Access Compliance Report

Public Rights-of-Way

(Curb Ramps)

Intersection ID: 44922	Main Street: MAPLE_PARK_LN	Cross Street: ROBUR_CT	Location: NW
ADA ID: CFFC95028DDB	Ramp Type: PerpDiag	Initial Pass/Fail: Fail	Overall Compliance: No
Severity Score: 10			
Codes/Mitigation Info/Possible Solution		Field Measurements/Component Compliance

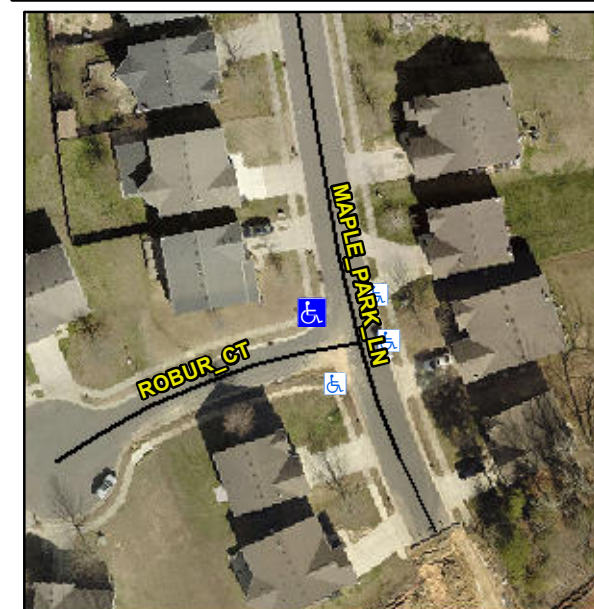
Not Found, R304.5.1, R304.5.3

Compliance	Description	Data	Compliance	Description	Data
N/A	Ramp Length (in)	46.0	Yes	Ramp Slope (%)	6.9
No	Ramp Width (in)	39.0	No	Ramp XSlope (%)	3.2
N/A	Flare Type LT	N/A	N/A	Flare Type RT	N/A
N/A	Flare Slope LT (%)	N/A	N/A	Flare Slope RT (%)	N/A
N/A	Flare Traversable LT?	N/A	N/A	Flare Traversable RT?	N/A
N/A	Landing Length (in)	N/A	N/A	DWS Provided?	N/A
N/A	Landing Width (in)	N/A	N/A	DWS Contrast?	N/A
N/A	Landing Slope (%)	N/A	N/A	DWS Length (in)	N/A
N/A	Landing X Slope (%)	N/A	N/A	DWS Full Width?	N/A
N/A	Landing Curb? (Y/N)	N/A	N/A	DWS Offset (in)	N/A
N/A	Shared Landing?	N/A			
N/A	Gutter Ponding?	N/A	N/A	Gutter Slope (%)	N/A
N/A	Gutter Lip Ht (in)	N/A	N/A	Gutter X Slope (%)	N/A
N/A	Painted X Walk1?	No	N/A	Painted X Walk2?	No
	X Walk 1 Direction	To S		X Walk 2 Direction	To E
N/A	X Walk 1 Width (in)	N/A	N/A	X Walk 2 Width (in)	N/A
	X Walk 1 Slope (%)	0.3		X Walk 2 Slope (%)	2.2
	X Walk 1 X Slope (%)	1.3		X Walk 2 X Slope (%)	2.0

Remove & Replace Curb Ramp With Two New Directional Ramps or Equivalent.
